Addendum 40 – UN Regulation No. 41

Revision 2 - Amendment 10

05 series of amendments – Date of entry into force: 30 September 2021

Uniform provisions concerning the approval of motorcycles with regard to noise

Figure 1
 Test track layout with dimensions in meters

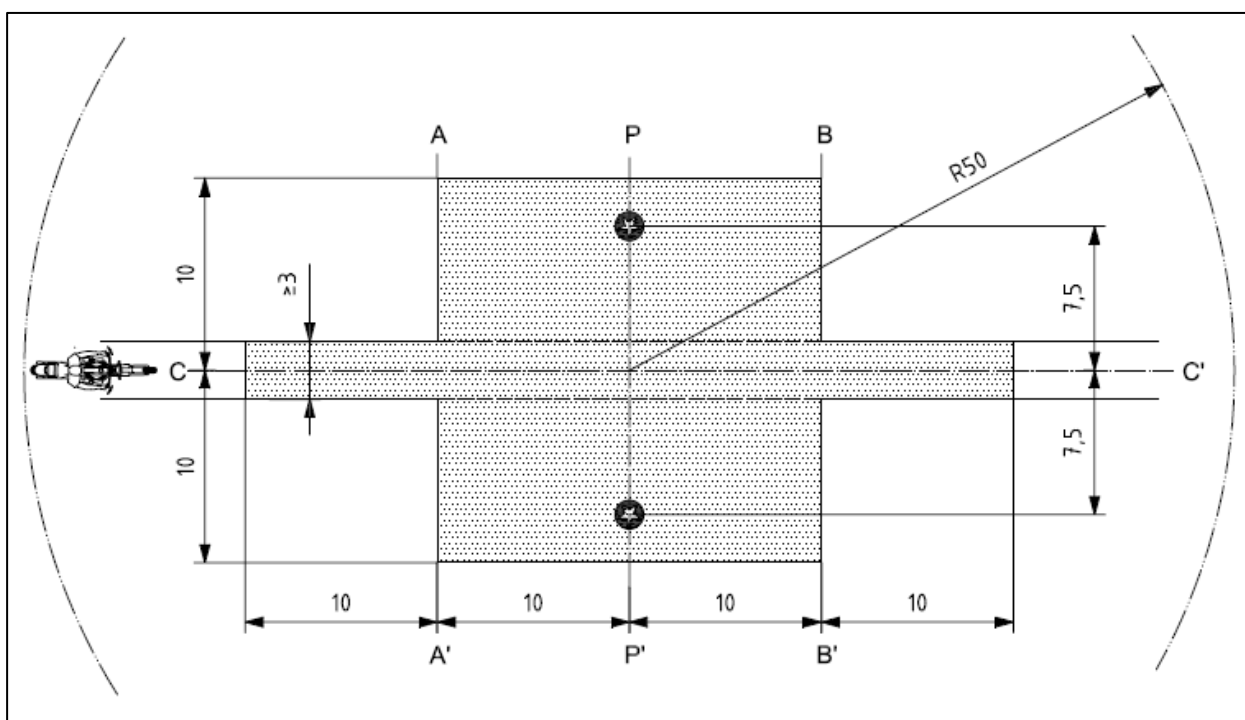
Annex 4,

Title, delete footnote 1 and amend to read:

"Test track layout"

Figure 1, amend to read:
